**AUTHORIZATION TO DISCHARGE UNDER THE  
NATIONAL POLLUTANT DISCHARGE ELIMINATION SYSTEM**

**The Town of Exeter, New Hampshire**

**13 Newfields Road  
Exeter, New Hampshire 03833**

**Squamscott River (Hydrologic Basin Code: 01060003)**

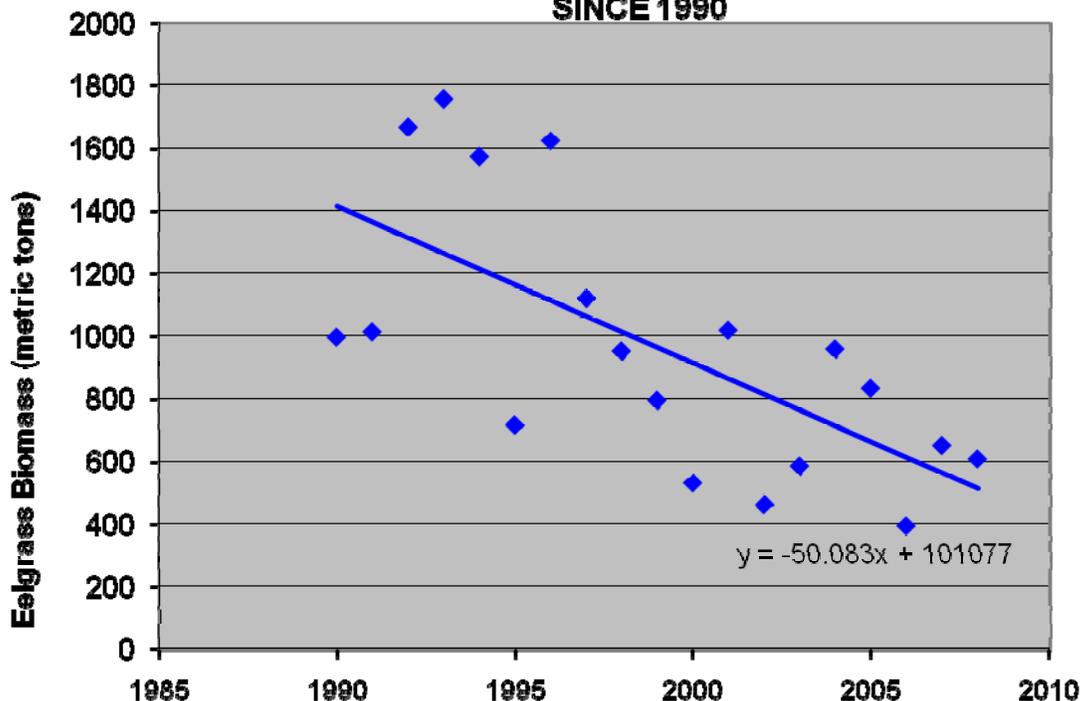
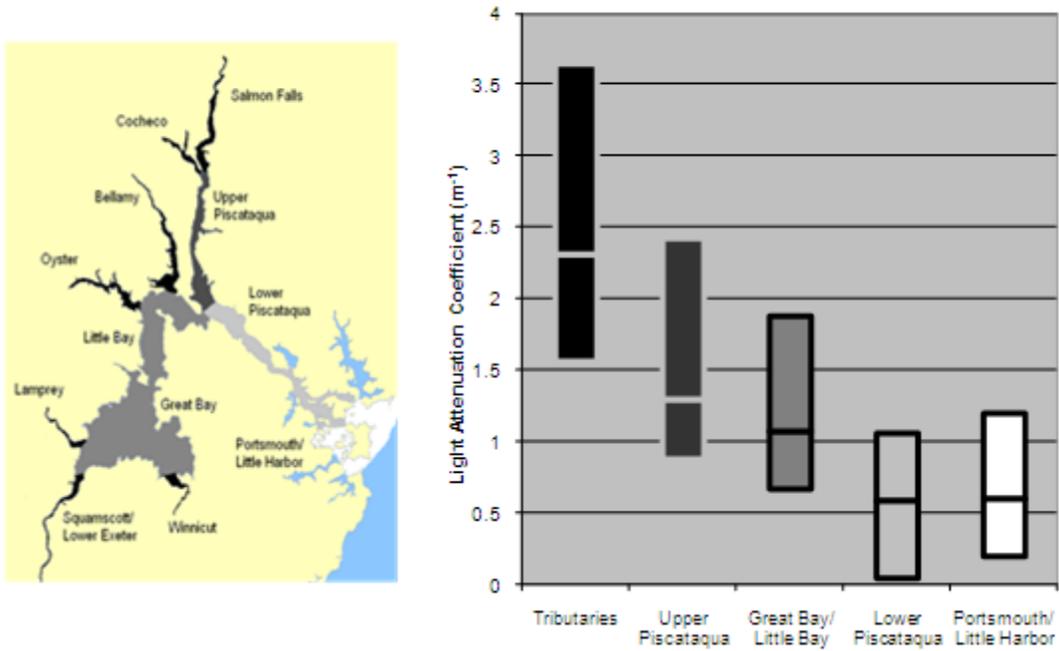
The Coalition incorrectly characterizes the figures in the Fact Sheet. Figure 5 in the Fact Sheet shows that light attenuation in Great Bay proper is reduced relative to better flushed portions of the estuary and Figure 4 indicates that there have been significant declines over time in eelgrass biomass in Great Bay proper. Macroalgae, epiphytes, and organic biomass resulting from excessive nitrogen concentrations are part of the overall accumulation of organic matter in the estuarine system that has a detrimental effect on the light levels that are critical for eelgrass health. It may be that the commenter intended to reference Figure 3 of the Fact Sheet, rather than Figure 4. In that case it is unclear why the commenter believes the comparison of these figures "confirms" that chlorophyll-a has little impact on transparency. These figures indicate identical patterns across the estuary as to both the magnitude and variability of chlorophyll-a concentrations and light attenuation, entirely consistent with the other data demonstrating a relationship between chlorophyll-a and transparency. See also Response #A1.

Figure 27: Relationship between Minimum Dissolved Oxygen and Chlorophyll-a at Trend Stations

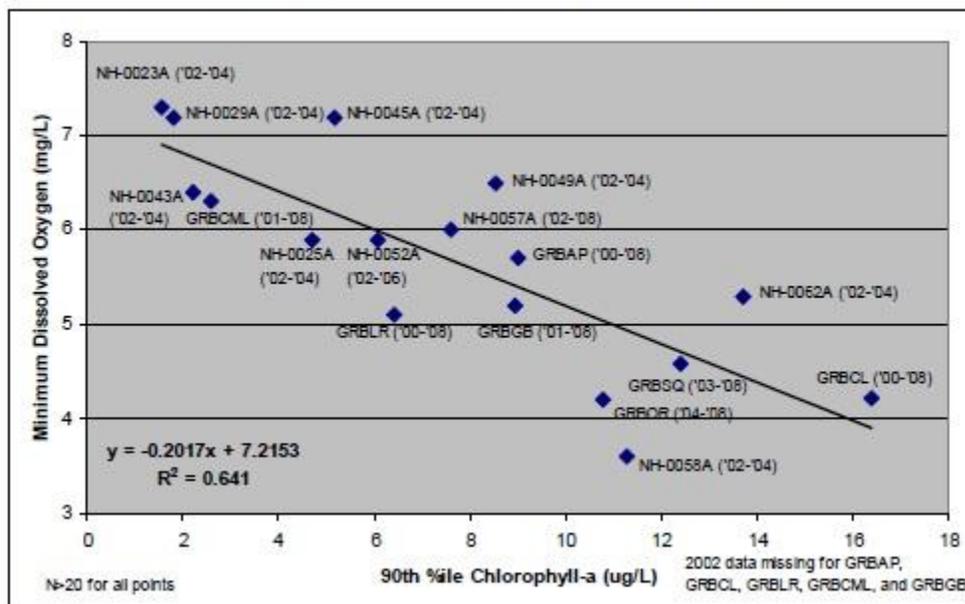
EPA also disagrees with the assertion that “[n]one of the river specific data indicated a significant relationship between minimum DO and algal growth.” Long-term trend monitoring from two stations in the Squamscott River (GRBCL and GRBSQ) are part of the statistical analysis performed by NHDES in connection with the draft numeric nutrient criteria showing a statistically significant relationship between minimum DO and 90<sup>th</sup> percentile chlorophyll-a. (NHDES, 2009, Figure 27 (reproduced below)).

The data for the Squamscott River are entirely consistent with data at the other trend stations, as the regression is essentially the same if the Squamscott River stations are excluded (though with a lower statistical significance with the lower sample size). See Figure 3.

Figure NUT3-1: Long-term trends for chlorophyll-a concentrations measured monthly at Adams Point in Great Bay

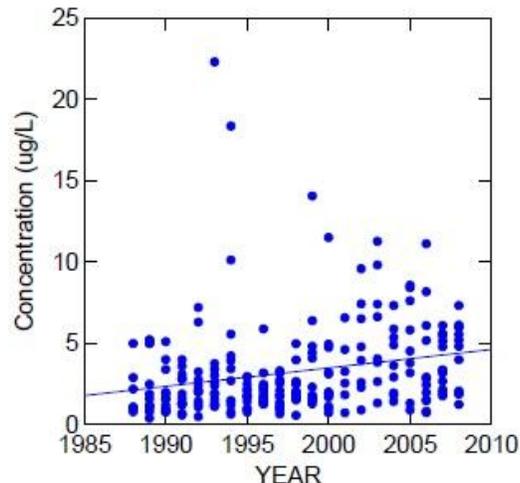
EPA disagrees with the Coalition's contention, based on selective use of data, that chlorophyll-a concentrations in Great Bay did not increase between 1993 and 2000 and therefore could not have contributed to eelgrass decline. The average annual concentrations shown in Exhibit 8 masks the trend that is apparent when the full dataset is considered. The PREP 2009 Environmental Indicators Report Figure NUT3-1, reproduced below, shows a statistically significant increasing trend between 1988 and 2008, with very obvious peaks in maximum chlorophyll-a in 1993 and 1994, just prior to the documented onset of eelgrass decline in 1996 (PREP, 2009b). EPA therefore does not accept the commenter's assertion that algal growth could not have been the cause of eelgrass decline.

EPA notes that the same figure the commenter cites as showing that algal levels increased by only 1 ug/l from 2001 to 2008 (a box and whisker plot) also shows that the 75<sup>th</sup> percentile concentrations increase by over 3 ug/l, or more than double, in the same period. Indeed, this is consistent with the commenter's own Exhibit 8, which shows annual averages ranging from approximately 2.4 to 6 ug/l in 2001 to 2008, compared to annual averages consistently below 2 ug/l prior to 2001. However, EPA notes that more recent data do not indicate a statistically significant increasing trend in chlorophyll-a through 2011 in Great Bay proper (PREP, 2012), in contrast to the analysis based on data through 2008 (PREP, 2009b). This is consistent with the strong impact of macroalgae on eelgrass in Great Bay proper.

Figure NUT1-5: Nitrogen loads to the Great Bay Estuary from different sources in 2009-2011

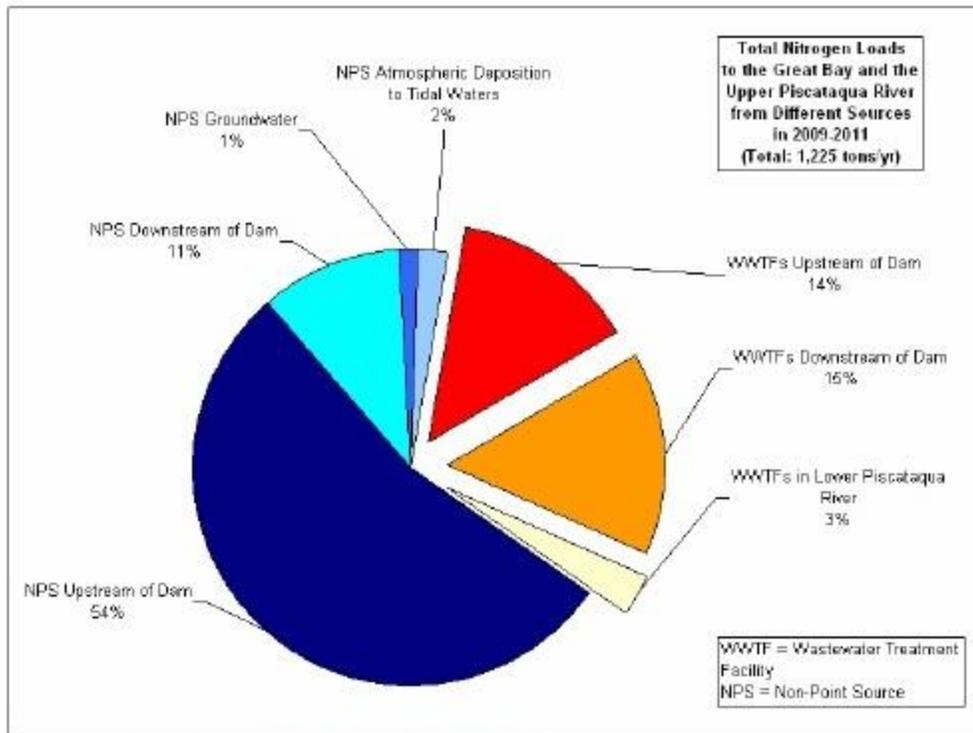
Exhibit 11 does not show municipal loads, only discharge flows from selected Great Bay POTWs during dry weather. There are little data available to indicate whether there has been an increase in nitrogen POTW loadings as these facilities were not reporting nitrogen concentrations or loads under their past permits. Rochester is a clear example of this where nitrogen discharge concentration levels have increased over time resulting in an increase in nitrogen discharge loadings independent of any flow increase. Quarterly monitoring provided by Rochester indicates that for 2001 – 2006 total nitrogen discharge levels ranged from 13 -18 mg/l and for 2007 – 2011 total nitrogen discharge levels ranged from 20 – 35 mg/l. Moreover, even if the recent increase in loads were primarily attributable to nonpoint sources, the fact is that total loadings exceed acceptable loadings and the point sources contribute significantly to these exceedances. Additionally, since permitted flows exceed actual flows, the potential for increased point source discharge loadings in the future is significant and needs to be addressed.

The estimate that 30% of the total loading of nitrogen is from point sources is an estimate based on the entire estuary, which was included in the *2009 State of the Estuaries Report*. The actual reported number is 31%. (PREP, 2009a at 12). EPA notes that the most recent calculations for 2009 to 2011 indicate that point sources account for 32% of the nitrogen load to the Great Bay and Upper Piscataqua River. (PREP, 2012, Figure NUT1-5 (reproduced below)).
